**CITY OF CARLTON
PLANNING COMMISSION AGENDA
MONDAY, DECEMBER 11, 2023, 6:00 P.M.
VIA ZOOM AND 945 WEST GRANT STREET**

To: Members of the Planning Commission
From: Scott Whyte, Contract Planner for the City of Carlton
Subject: Continued Public Hearing for 2nd Street Preliminary Subdivision, SUB 2023-02
Date: December 4, 2023, for the December 11, 2023, meeting

To: **City of Carlton Planning Commission**
 From: **Todd E. Mobley, PE**
 Date: **November 21, 2023**
 Subject: **SUB 2023-02; 2nd Street Subdivision – E Taylor Street Alignment Options**

S 2ND STREET SUBDIVISION Exhibit B-4

Figure 2: Poor Sight Distance from W Taylor Street

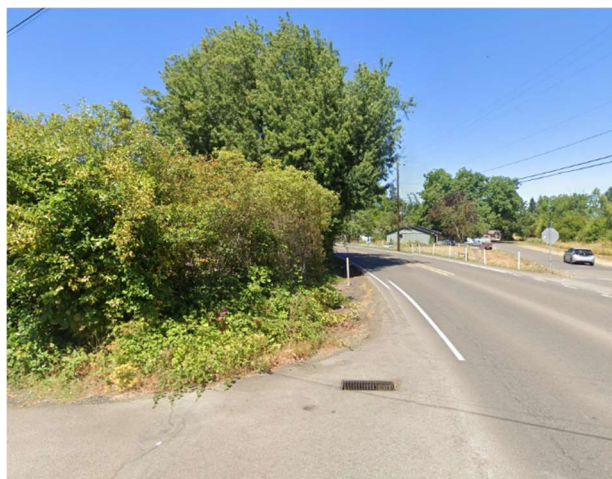
Staff agree with the memo observations about existing conditions at the Hwy. 47 / Taylor Street intersection. In part, the applicant's memo provides a photo of existing sight distance viewed from existing Taylor Street (looking north) at Highway 47. Staff finds these conditions to remain unchanged as the applicant's site is bounded by the former S.P.R.R right-of-way (west) and no connection of Taylor to Highway 47 is proposed as part of the applicant's subdivision proposal. With or without the stub of Taylor inside the project site, existing conditions remain unchanged.

Figure 3: Alignment 1, Queuing & Traffic Flow

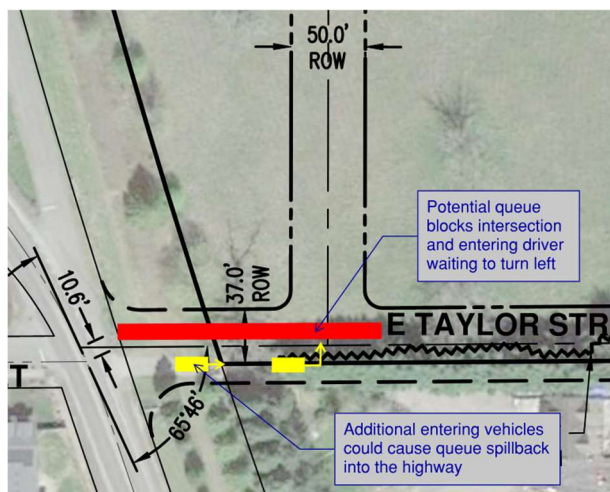
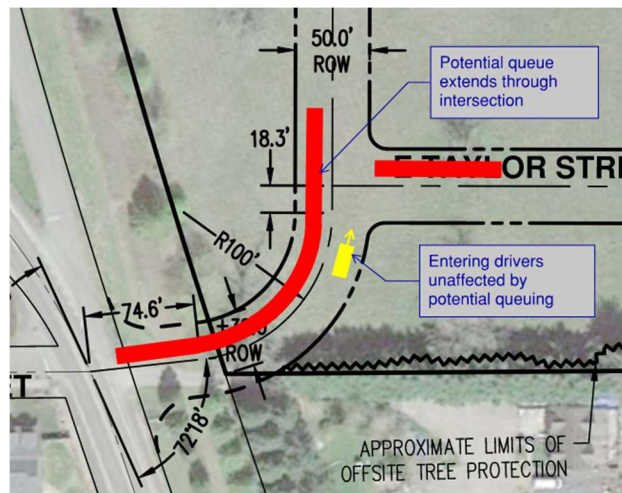
Supplemental Finding - Potential vehicle spillback as safety concern lacks data. As stated above, no connection of E. Taylor Street to Highway 47 is proposed via the subdivision proposal. Figures 3 and 5 of the applicant's memo show red and yellow lines, indicating potential vehicle queue that might block access or spill back onto Highway 47 if connection of E. Taylor Street were constructed in the future via alignment options 1 and 2. The memo concludes that Alignment Option 3 (no connection of Taylor Street / Hwy. 47) provides the safest transportation system for the city (page 4). Staff observe how queue methodology, circumstances, assumptions, and frequency of occurrence were not provided.

**CONCEPTUAL E TAYLOR STREET ALIGNMENT 1
S 2ND STREET SUBDIVISION
CARLTON, OREGON**

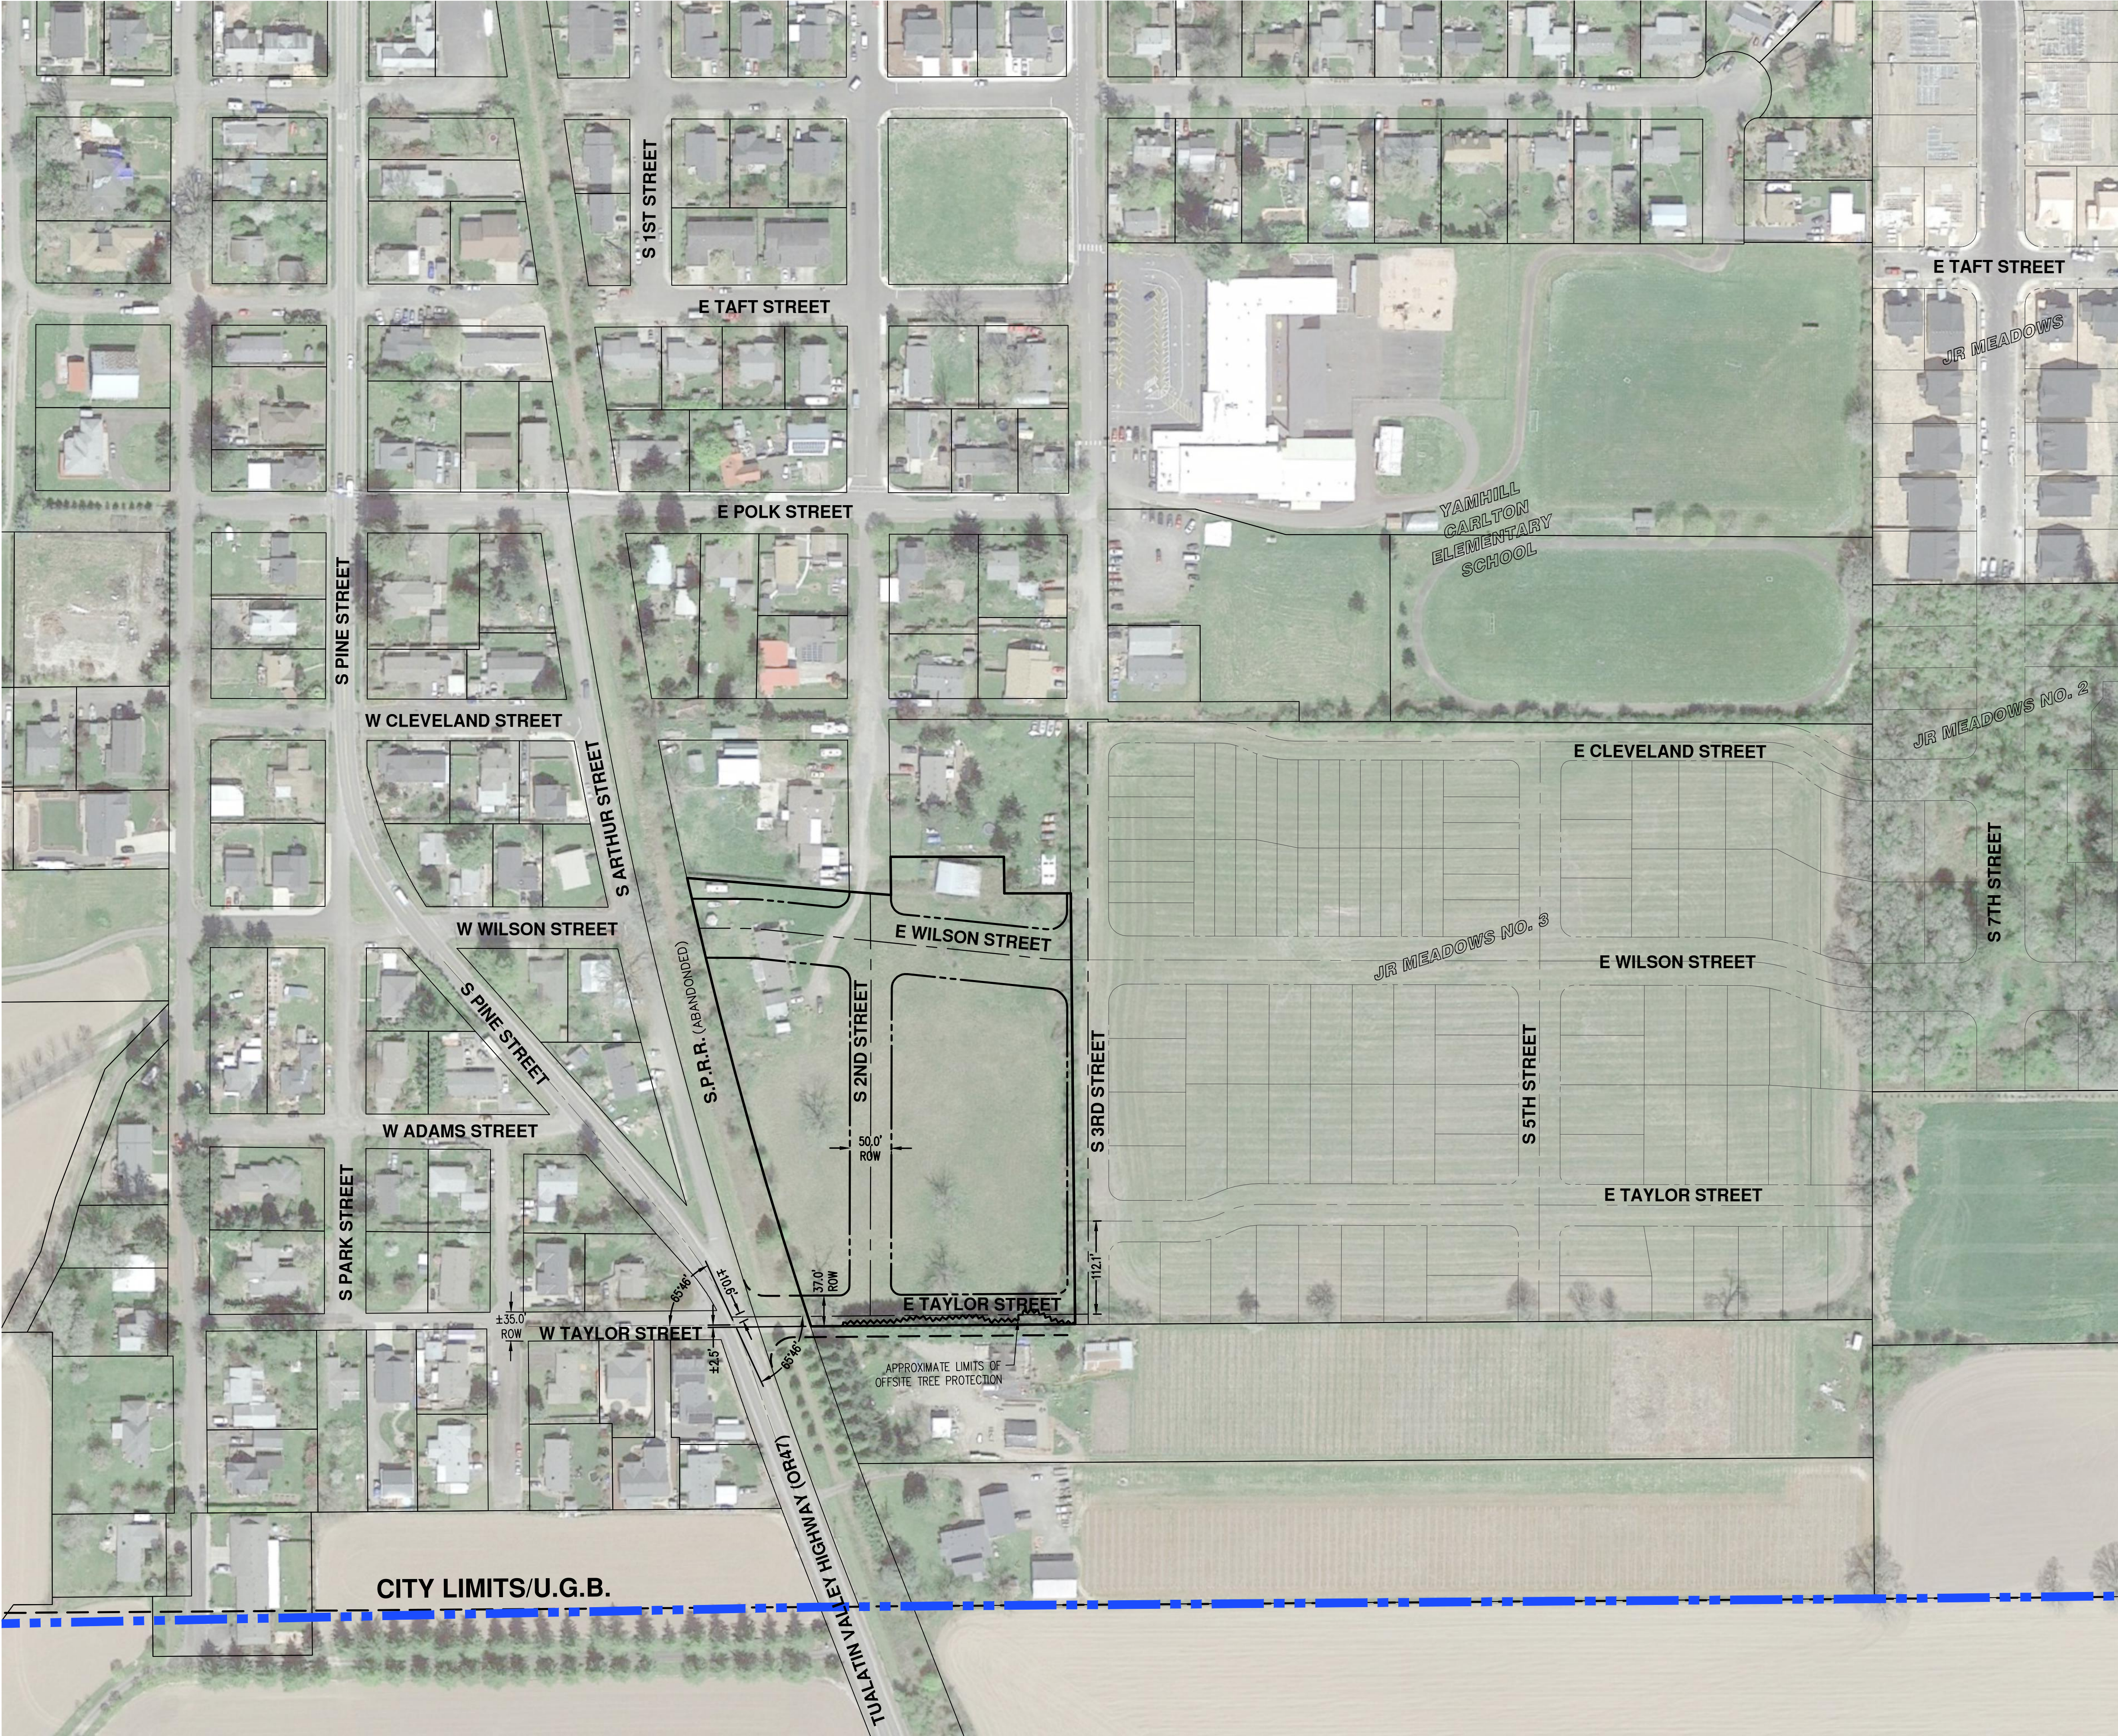
Supplemental Findings – Staff Review of Alignment Option 1: In review of the applicant’s memo (describing three alignment options) staff observe Alignment Option 1 (Figure 1 thereof) to identify 112 feet of distance between the centerline of E. Taylor Street (within the proposed subdivision) and the centerline of Taylor Street where approved within the JR Meadows 3 subdivision to the east. In review of Alignment Option 1, staff confirm that Taylor Street is shown consistent with the Future Street Plan (above). However, by positioning E. Taylor entirely along the south boundary of the site and not adjusting through the subdivision to where Taylor is approved with JR Meadows 3, the result is a “*staggering of street alignments resulting in “T” intersections*” as the standard in C describes and discourages. Staff also observe standard in C to reference “*existing streets*” and how that portion of E. Taylor Street, where approved in JR Meadows 3, does not exist (yet). As shown in Alignment Option 1, the western stub of E. Taylor Street aligns with existing Taylor Street (west side of Highway 47). Accordingly, to this portion of Option 1 staff finds the standards in C and D (above) met. Staff also observe no details provided for Option 1 (e.g., number of lots, shape, % intended for detached / attached, etc.). Plan details would be necessary for staff to review in support of Option 1.

**CONCEPTUAL E TAYLOR STREET ALIGNMENT 2
S 2ND STREET SUBDIVISION
CARLTON, OREGON**

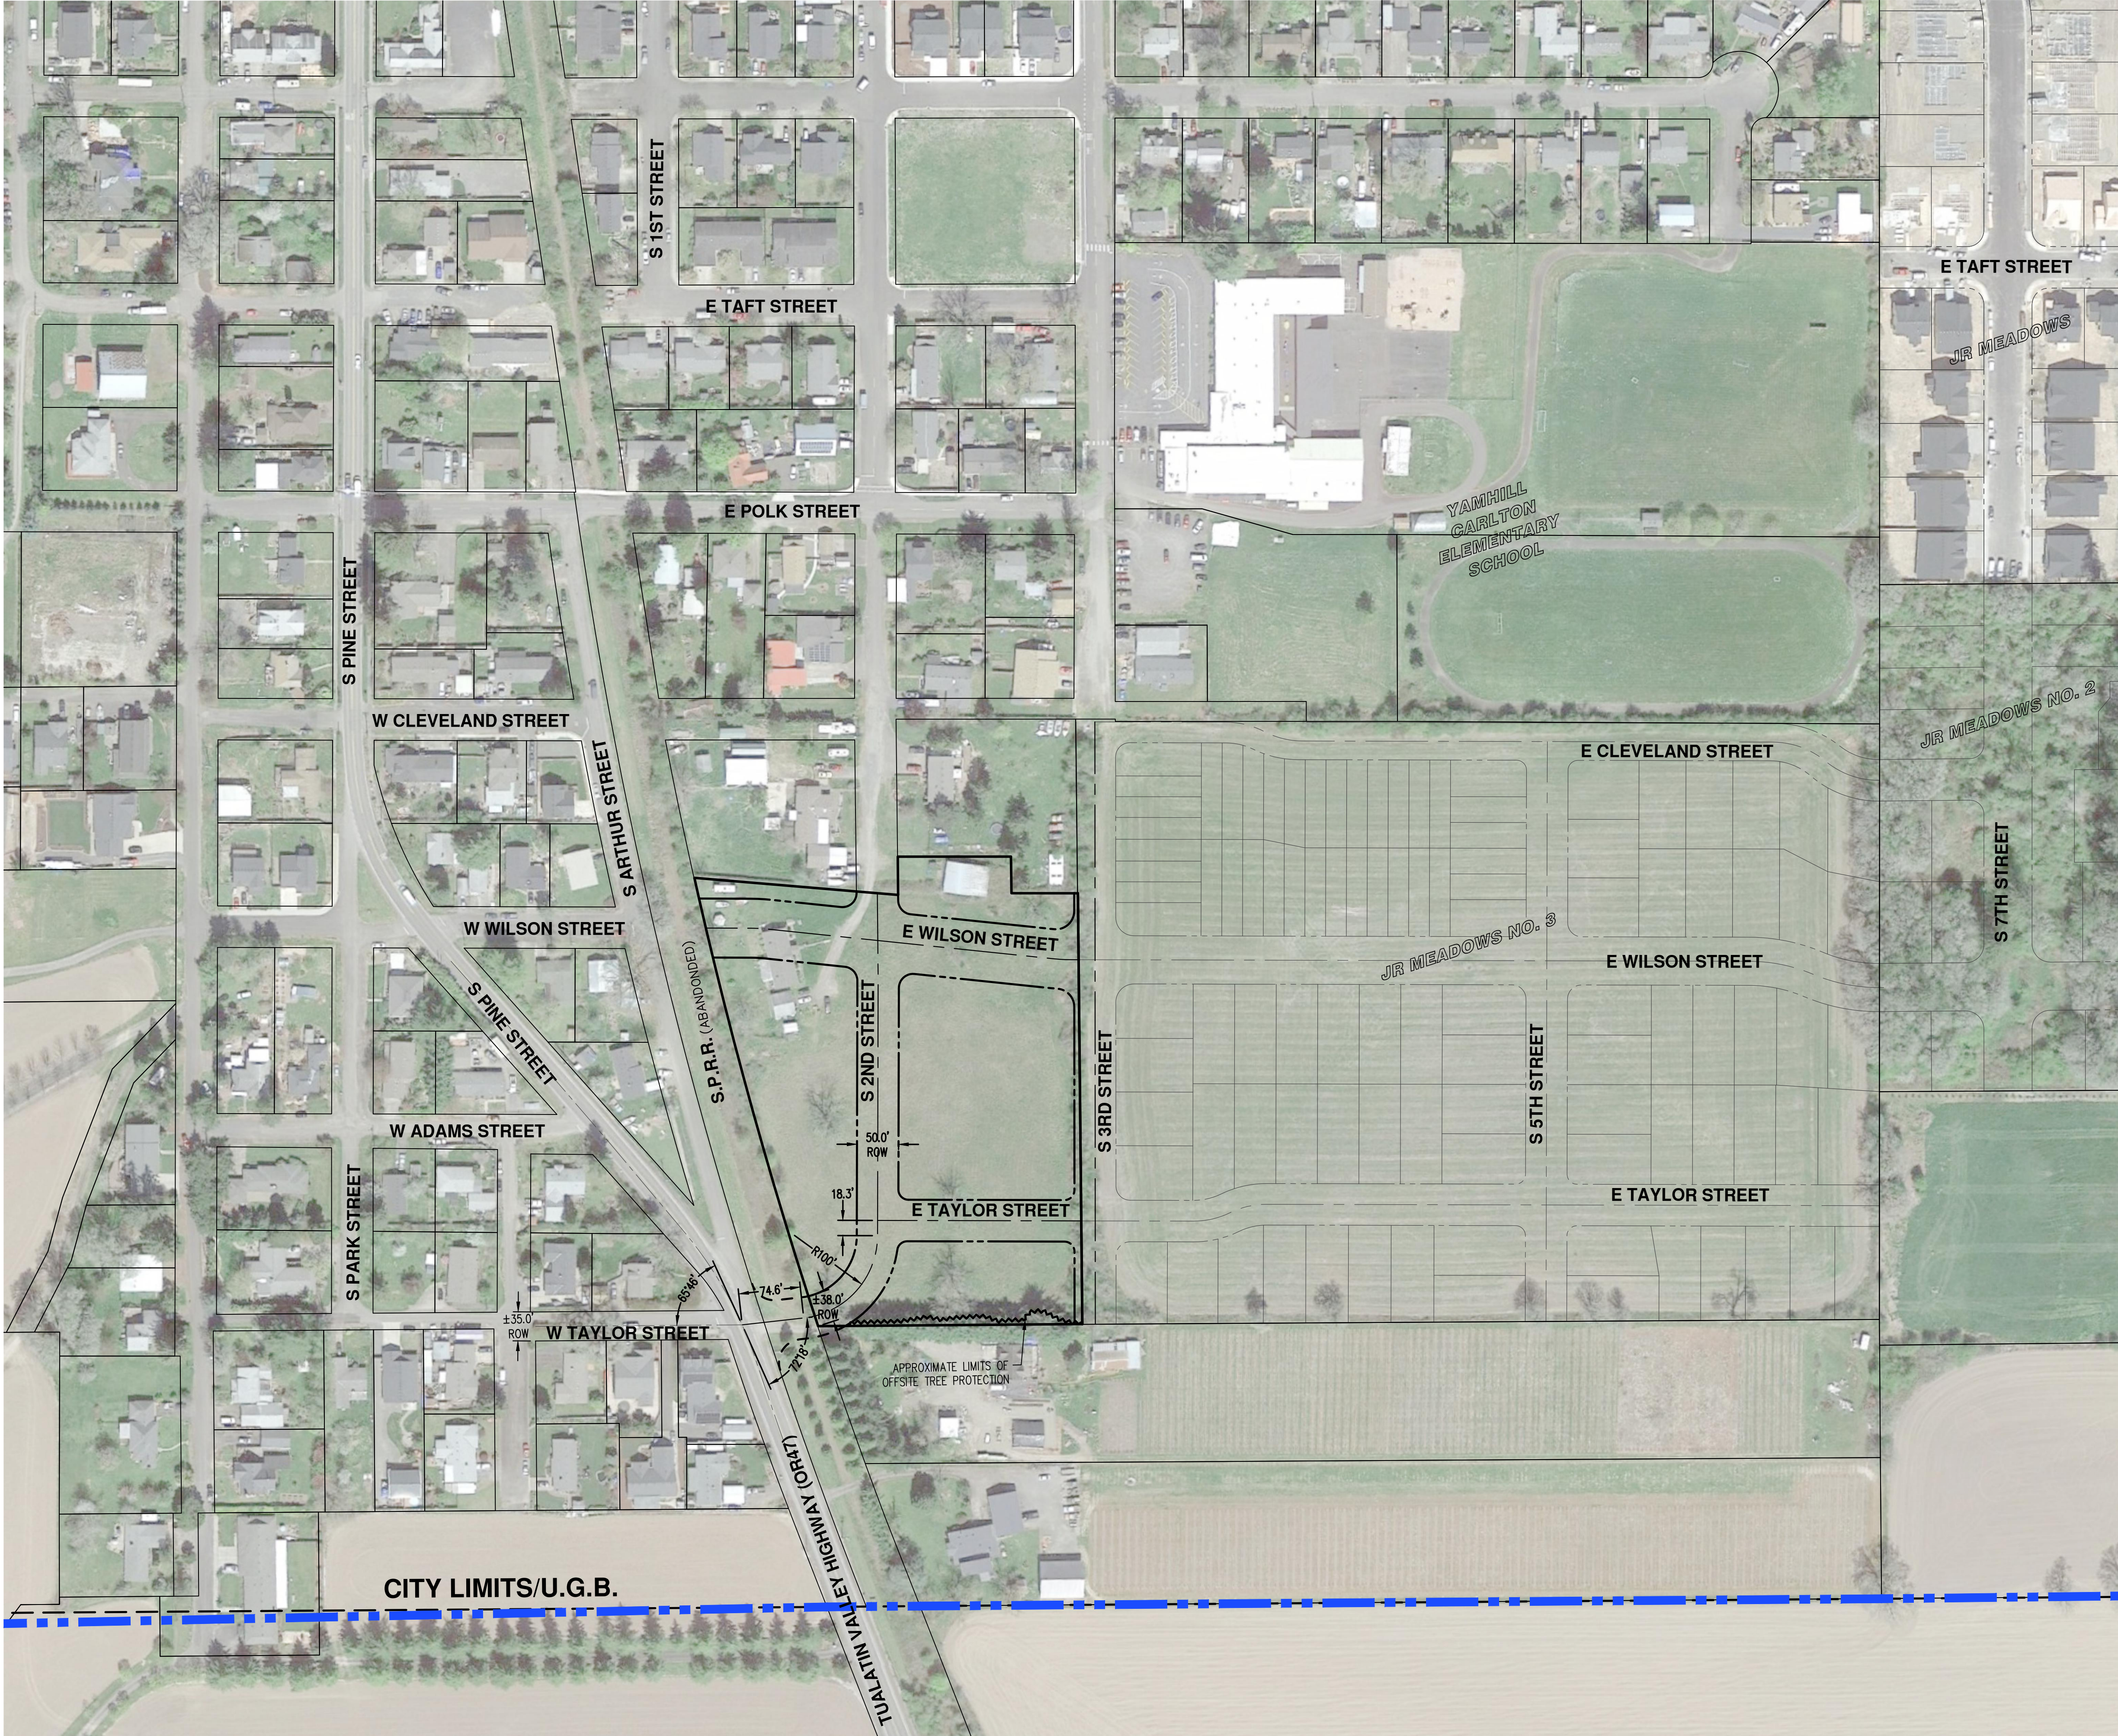
Supplemental Findings – Staff Review of Alignment Option 2: Staff finds Alignment Option 2 (depicted in Figure 4 of the memo) to better meet the standard in C above as this plan shows streets aligned east and west and connected via centerlines thereof (i.e., to Taylor Street where approved for JR Meadows 3 and to Taylor Street where existing on the west of Hwy. 47). For Option 2, staff also observe how the street configuration shown for Taylor and 2nd streets within the subdivision could be modified further to show 2nd Street intersect with Taylor Street instead of the applicant’s proposal of having Taylor Street intersect with 2nd Street as shown. This would also meet the standards in C and D above. For Option 2 staff again observe no details provided (e.g., number of lots, shape, % intended for detached / attached, etc.). These plan details would be necessary for staff to review in support of Option 2.
